**MANDATORY BULLETIN No. EV 97 – 016 a
SPORTSTAR – 015 a**

1. **CONCERNING TO:** Only the **EV-97 Eurostar** and **SportStar** airplanes **fitted with an autopilot**.
2. **REASON:** During a pre-flight inspection of a SportStar having an autopilot installation, jamming of the lateral control moved fully to the right was found. The cause was a failure of a zip tie attaching the fabric boot to the rods which allowed the compressing of the fabric boot covering aileron servo rod and aileron rod at the fuselage right side. Compressed fabric boot in combination with a small clearance between the right upholstery panel and aileron servo rod caused jamming of the lateral control – see Appendix 1.

Appendix 2 Modification of Fabric Boot Attachment and Upholstery Panel Shape.

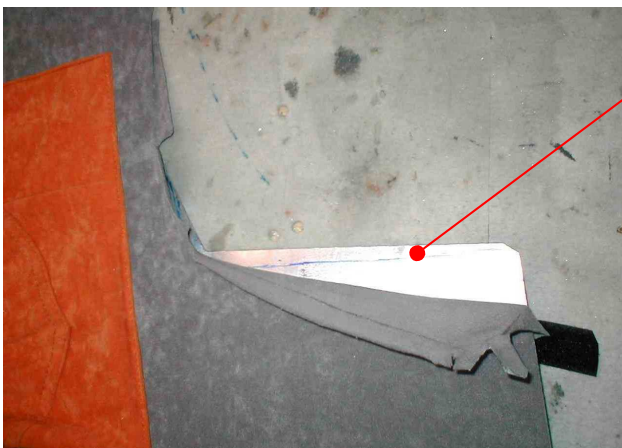
1. Use 1 zip tie to fix the fabric boot to each rod as shown on the picture. Move the control stick fully left and right to check aileron full deflections. If full movement is impossible then adjust position of the zip ties and check again. Apply a glue to fix fabric boot ends to the rods.

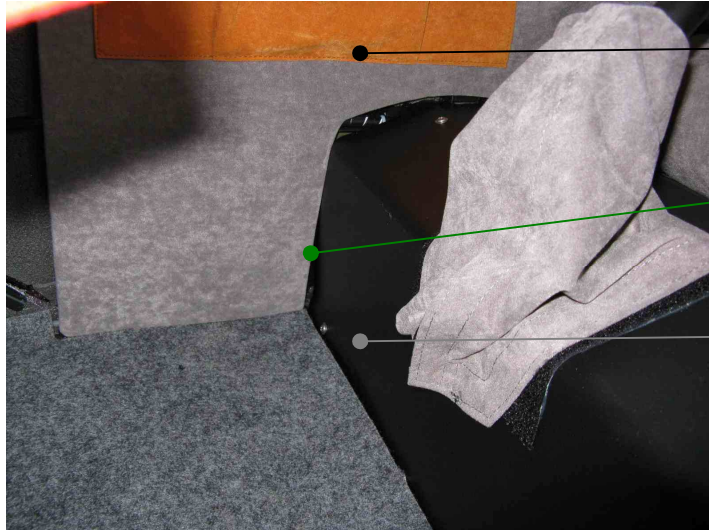
2. Remove right seat upholstery. Remove hand control right cover in front of the right seat. Visually check clearance between the front rod and edge of the upholstery panel. If the clearance is less than 10-12 mm i.e. ½" (see picture on previous page), then carefully remove right upholstery panel (its top edge is inserted under the fuselage side angle and further Velcro strips are used to fix panel to the fuselage side), carefully remove the upholstery in area of the cut out (see picture below), use pencil and rule to mark new shape of cut out, trim by means of snips, deburr, glue upholstery back to panel.

Front edge.
Enlarge the cut
out.

Front edge.
Cut out trimmed.

Re-install the upholstery panel. Re-install the hand control right cover.
